Addendum No. 2
To the Plans and Specifications of

Mobile Fire Station #19
1309 Azalea Road
Mobile, Alabama 36693

Four Pages + Attachment(s)
June 26, 2025

TITLE HYDROCARBON & SAND INTERCEPTOR
DRAINAGE STRUCTURE DETAIL

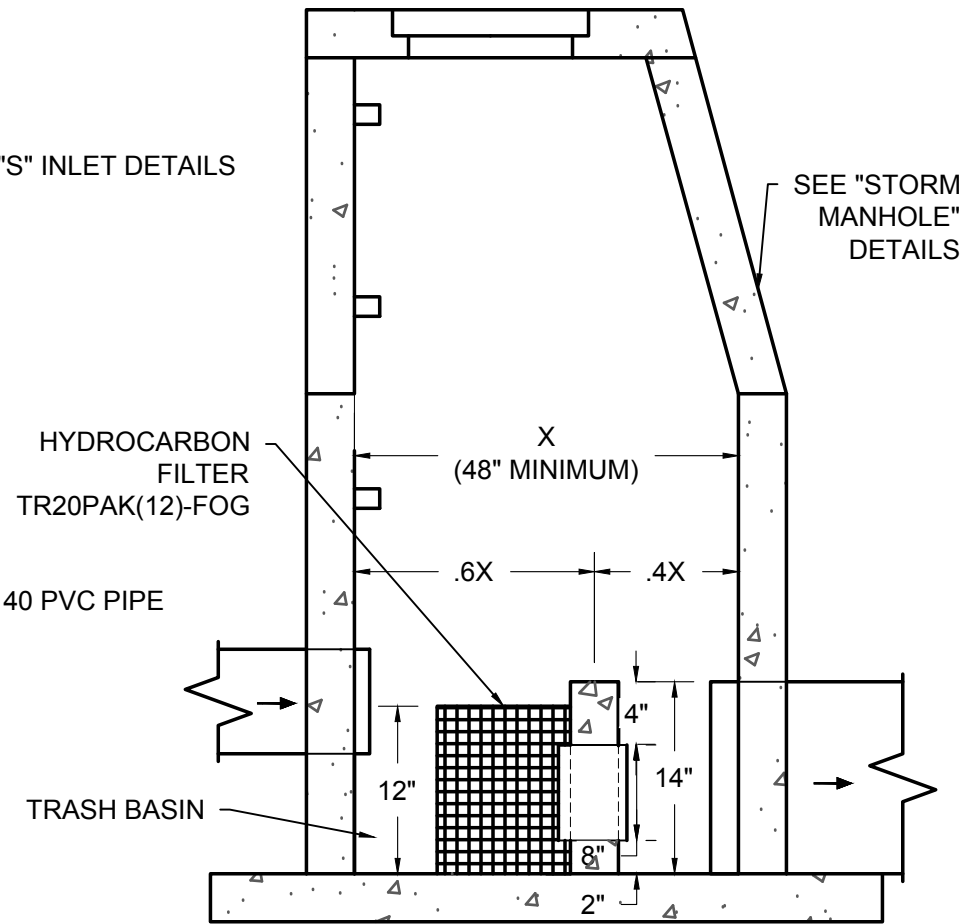
- C3. A video and inspection report of existing sewer line was emailed to all contractors separately, for information purposes only.
- C4. Drainage Structures labels "A" and "E", S-Type, shall be constructed as a modified S-Inlet per the attached detail "HYDROCARBON & SAND INTERCEPTOR DRAINAGE STRUCTURE DETAIL". Filter and frame shown in detail should be manufactured by Revel Environmental Manufacturing, Inc. or approved equal.

E105
 ENLARGED LIGHTING PLAN

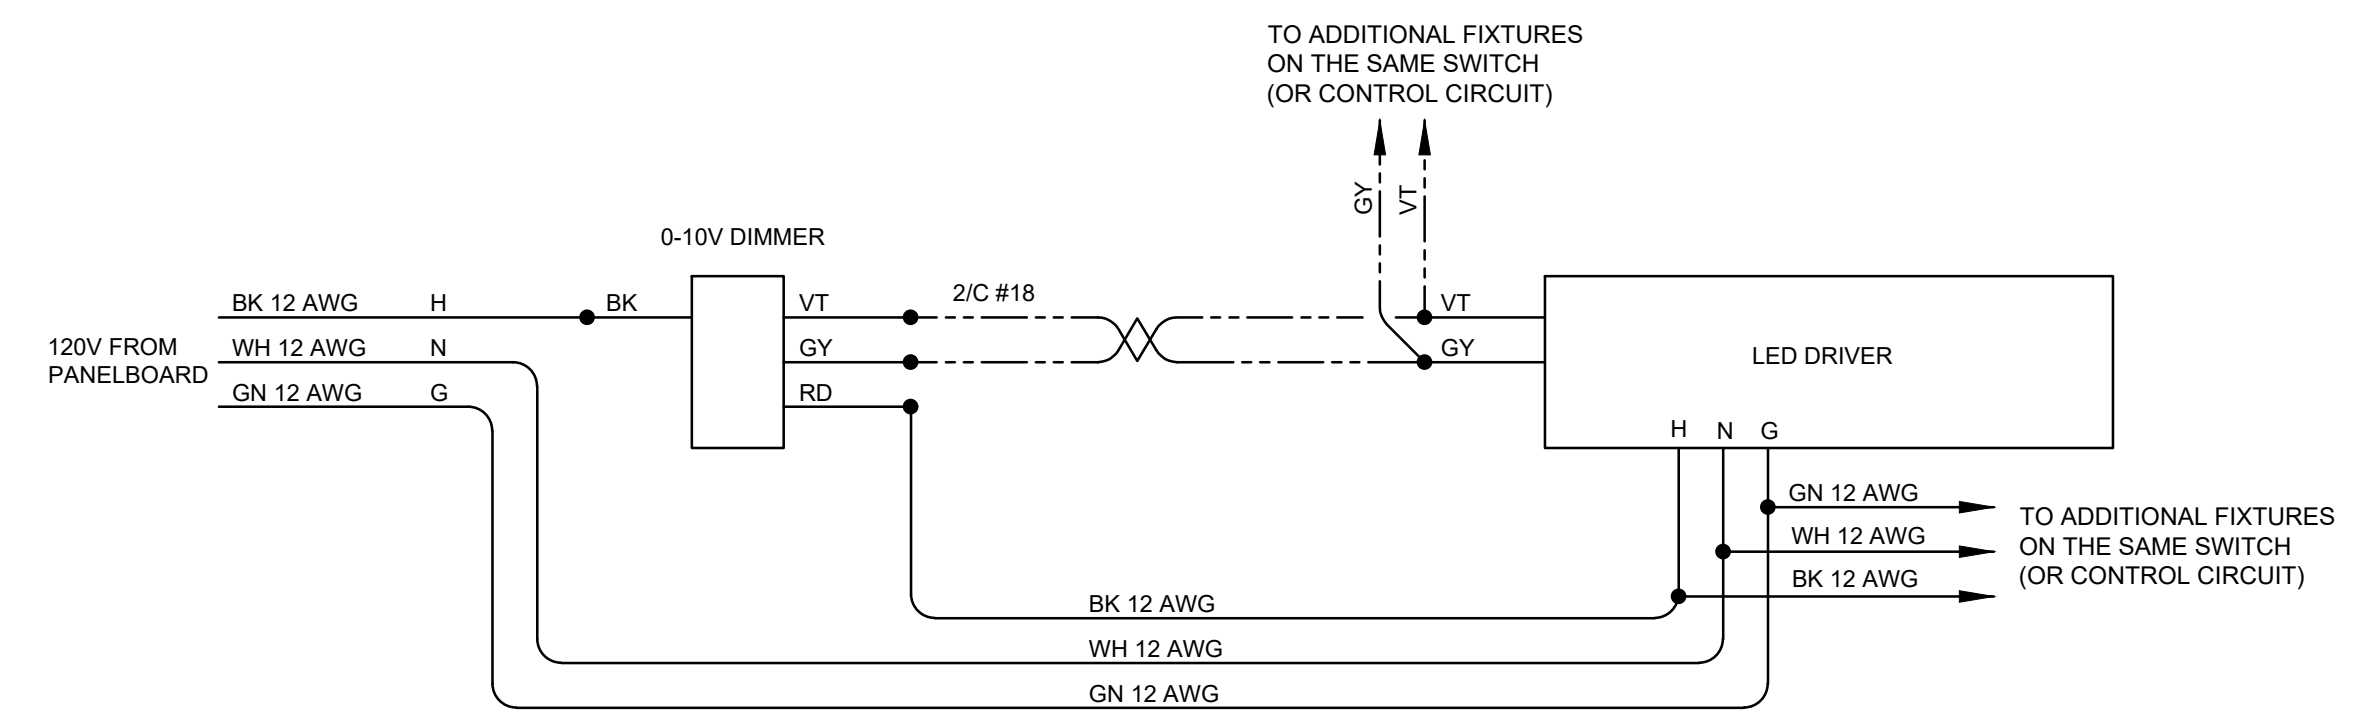
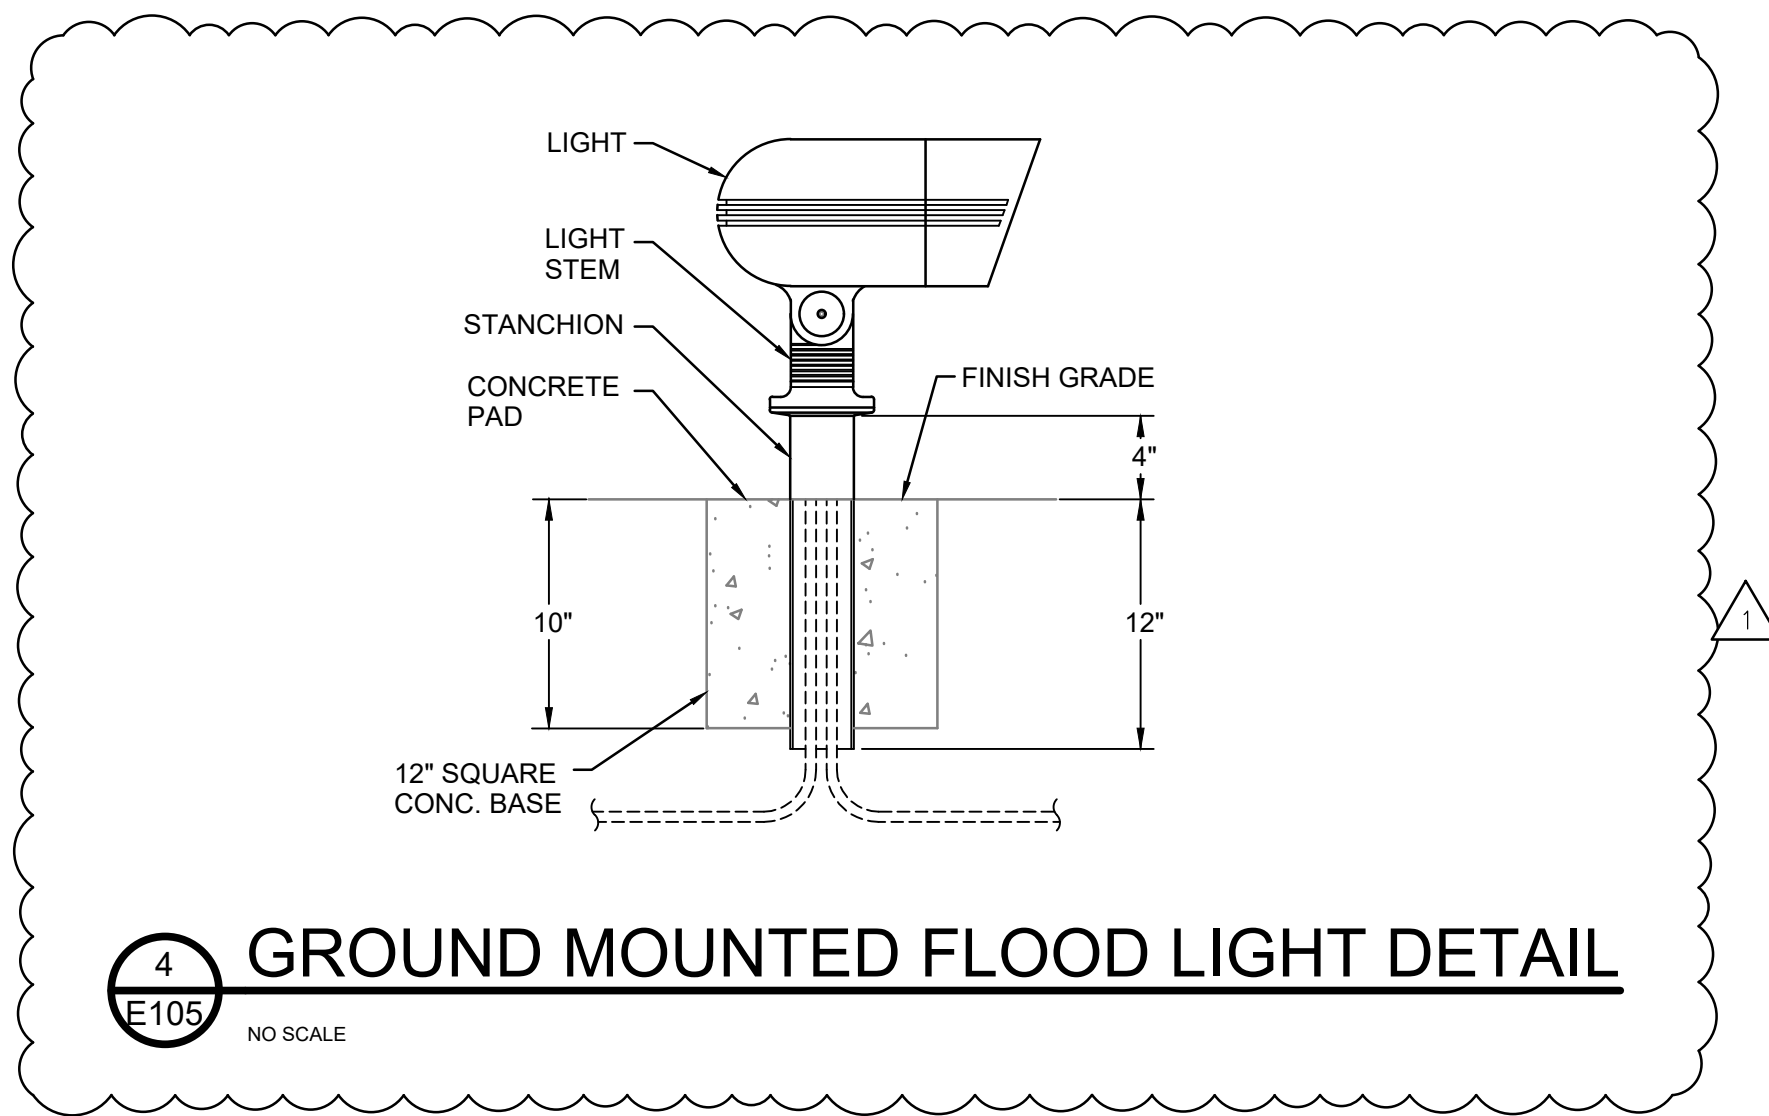
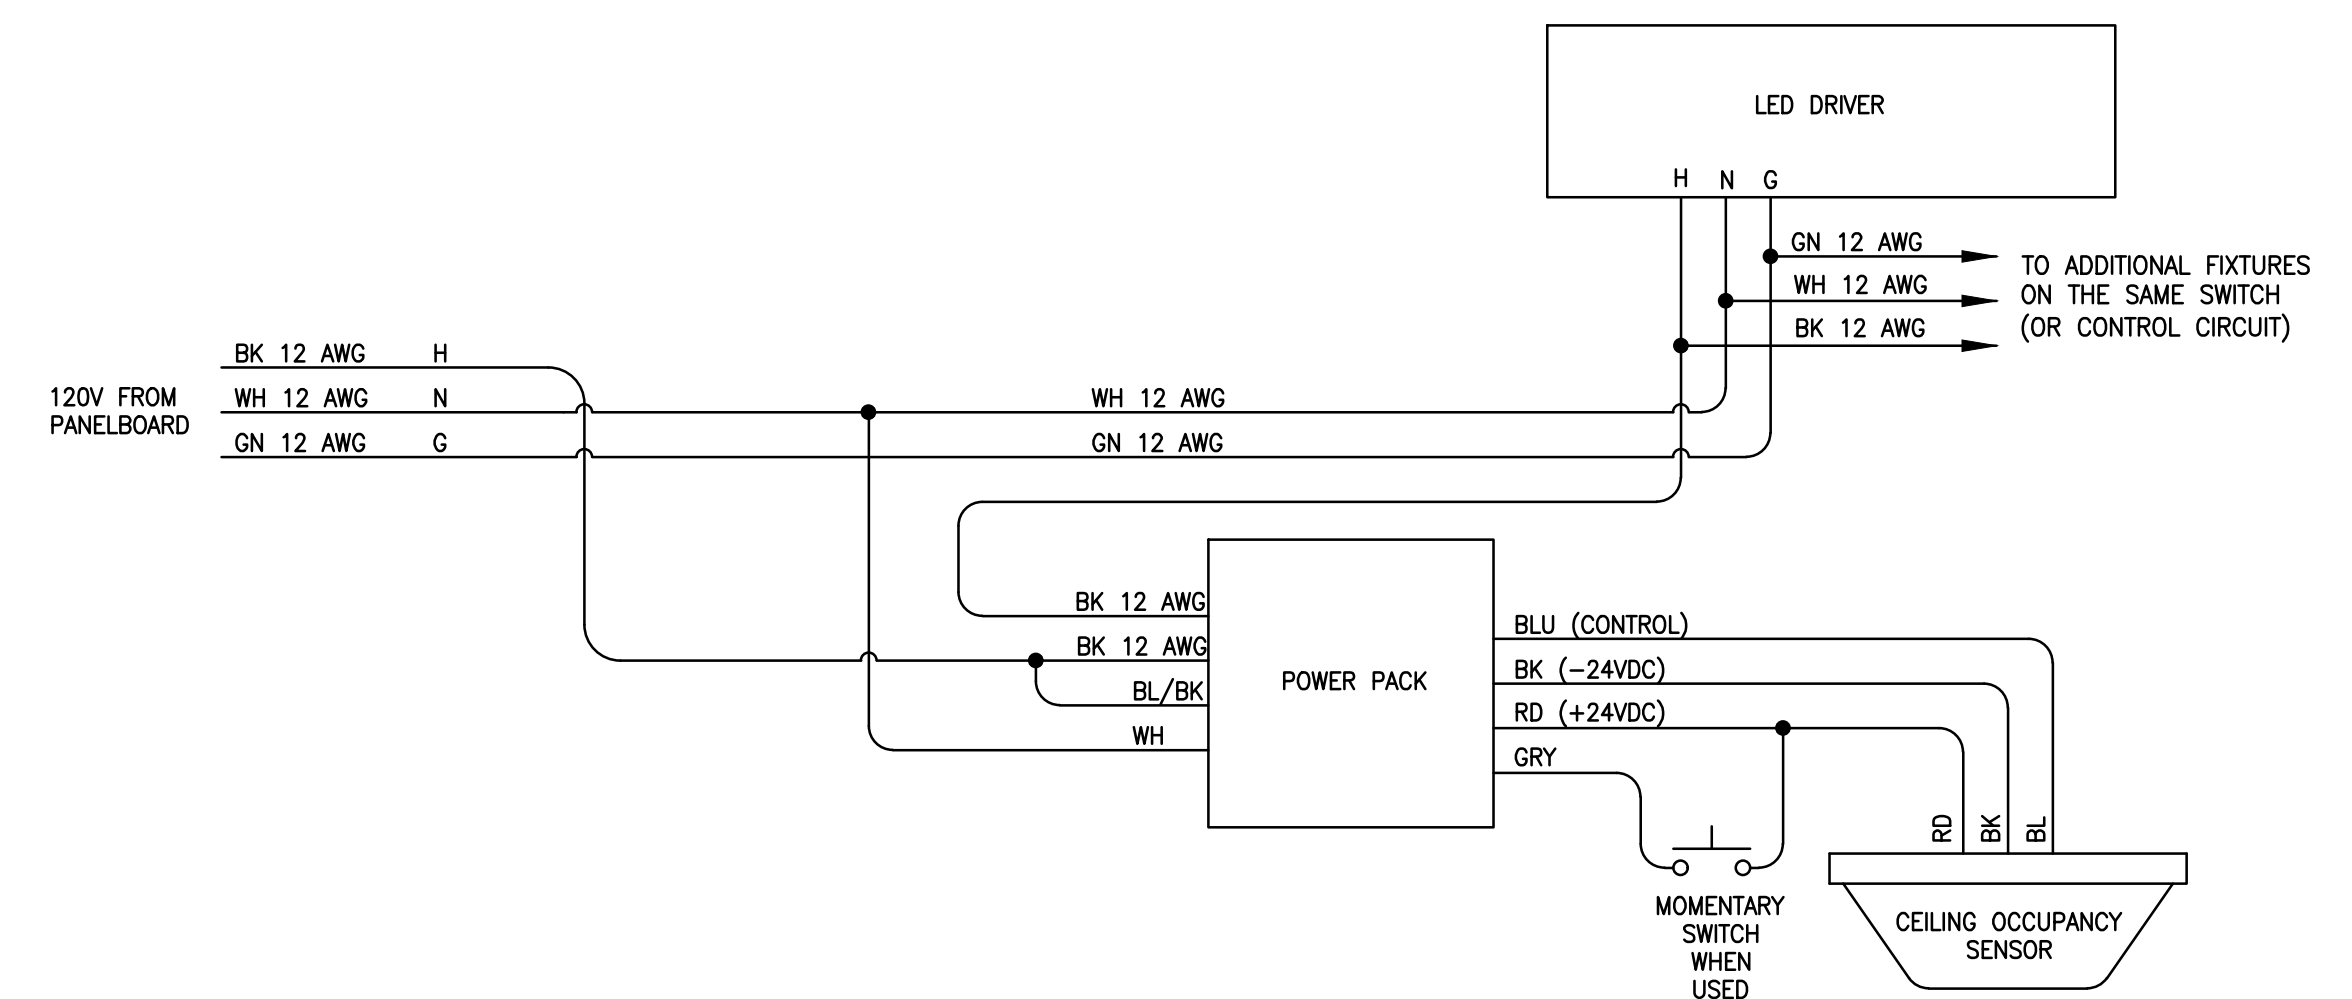
- E1. Sheet E105 – Detail has been added for concrete base at flagpole light fixtures. Fixture type UP has been added to the light fixture schedule.
- E2. Sheet ES101 – For all CCTV symbols on exterior of building, provide a 3/4” conduit from exterior through wall to above ceiling.

MECHANICAL SCHEDULES
AND NOTES

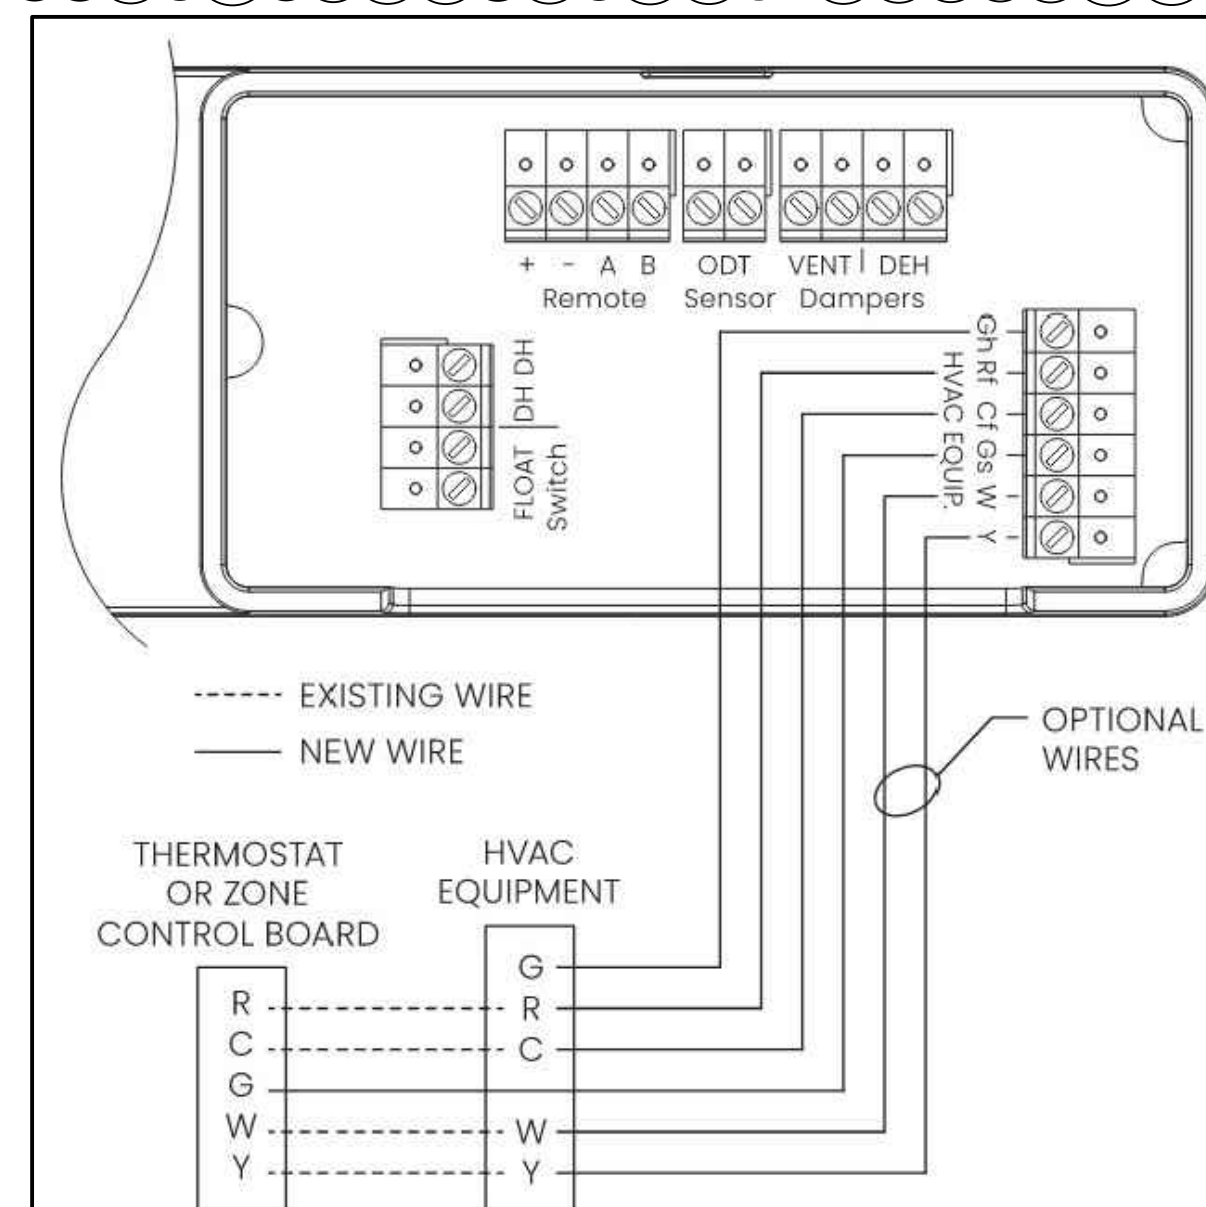
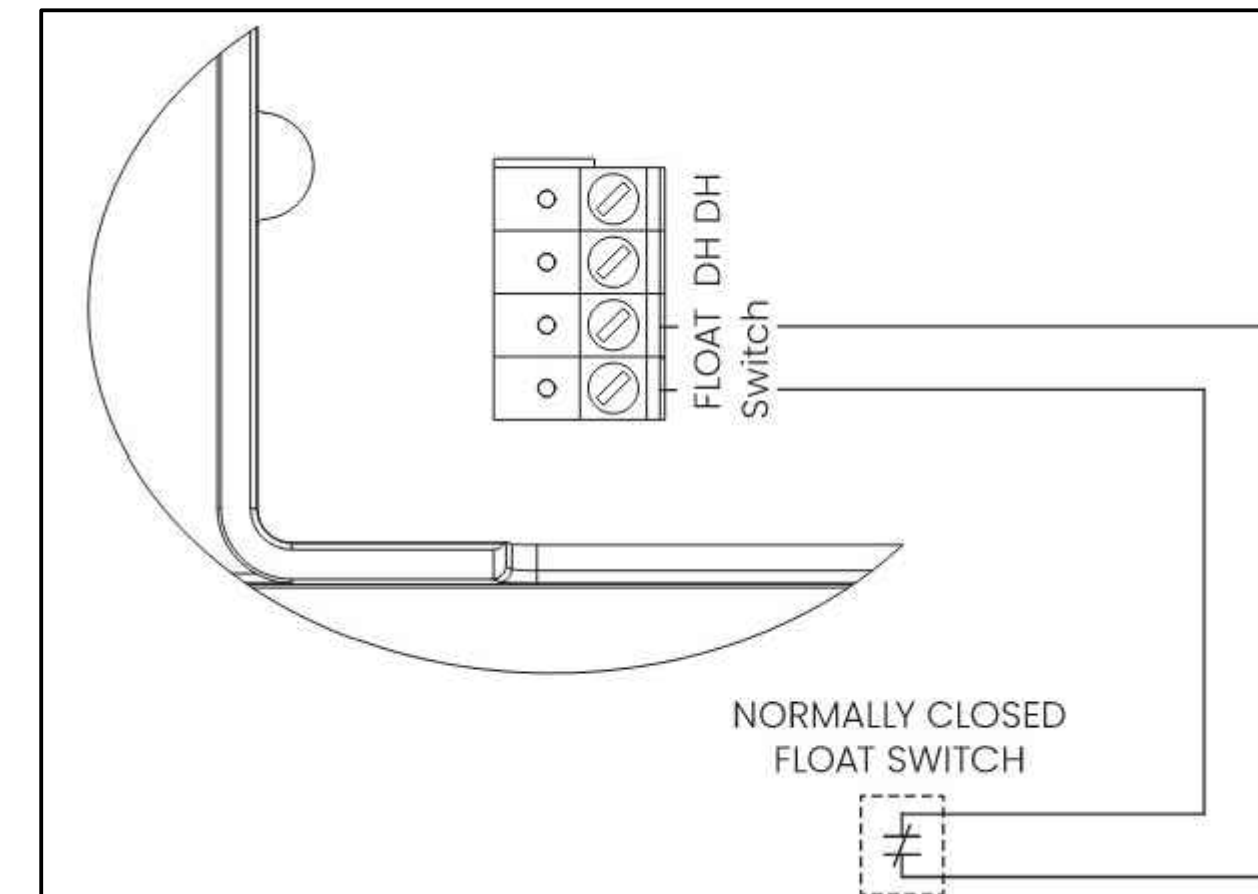
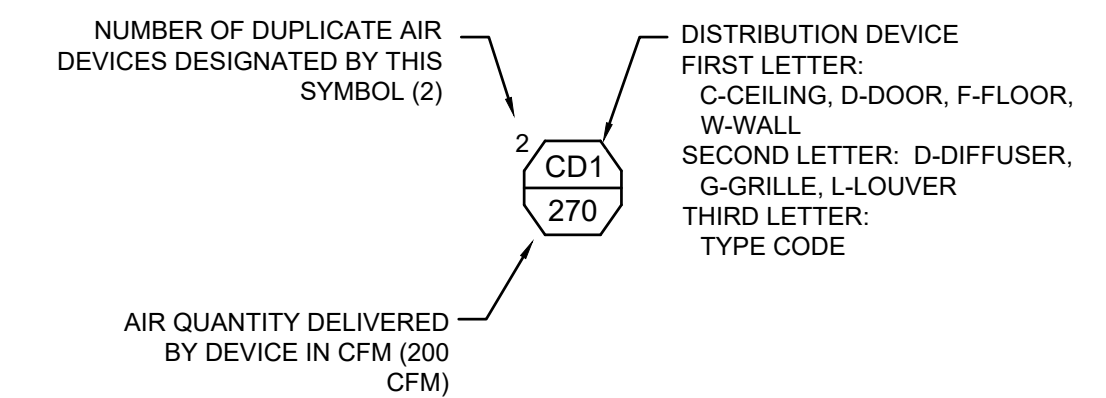
- M1. Sheet M100 – ADDED CO/NO2 SEQUENCE OF OPERATION. ADDED CO/NO2 SENSORS TO LEGEND
- M2. Sheet M101 – UPDATED FAN SCHEDULE TO REMOVE TIMER CONTROLS FOR RESTROOM EXHAUST FANS
